APPENDIX 1:
COPY OF DELEGATED REPORT

Delegated Report		Analysis sheet	Expiry Date:	10/05/2022
		N/A / attached	Consultation Expiry Date:	12/06/2022
Officer			Application Number(s)	
Elaine Quigley			2022/1065/P	
Application Address			Drawing Numbers	
2A Gate Street London WC2A 3HP			See draft decision notice	
PO 3/4	Area Team Signature	C&UD	Authorised Officer Signature	
Proposal(s)				
Erection of an additional storey at fourth floor level (following removal of the roof) and erection of a mansard roof extension to create a new one bedroom self-contained flat (Class C3) with external roof terrace and privacy screen, green roof and alterations to windows on front elevation at third floor.				
Recommendation(s):		Refuse planning permission		
Application Type:		Full Planning Permission

Application ref: 2022/1065/P
Contact: Elaine Quigley
Tel: 020 7974 5101
Email: Elaine.Quigley@camden.gov.uk
Date: 29 November 2022

Erection of an additional storey at fourth floor level (following removal of the roof) and erection of a mansard roof extension to create a new one bedroom self-contained flat (Class C3) with external roof terrace and privacy screen, green roof and alterations to windows on

Figure 1: Proposed front, side and rear elevations of the refused scheme (ref 2006/5115/P).

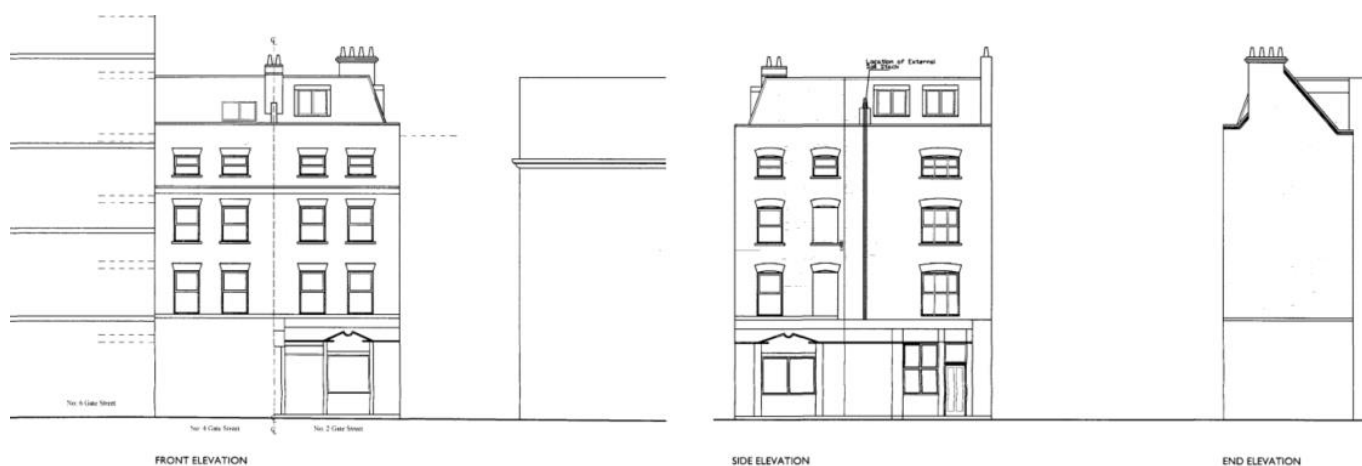
Planning permission was **refused** (ref 2006/5115/P) on 16/04/2007 for alterations to existing roof involving an increase in ridge height and formation of a new dormer window to the front and 2x to the side elevation in connection with the formation of an additional self-contained residential flat (Class C3) at roof level of the existing residential building (Class C3) with ground floor cafe (Class A1) (see figure 1 below illustrating proposal). The 2 reasons for refusal include:

1. design of the dormer windows and the detrimental impact on the character and appearance of the building and this part of Bloomsbury Conservation Area and
2. Inadequate size of the self-contained flat leading to substandard accommodation resulting in detrimental harm to the amenity of future occupiers.
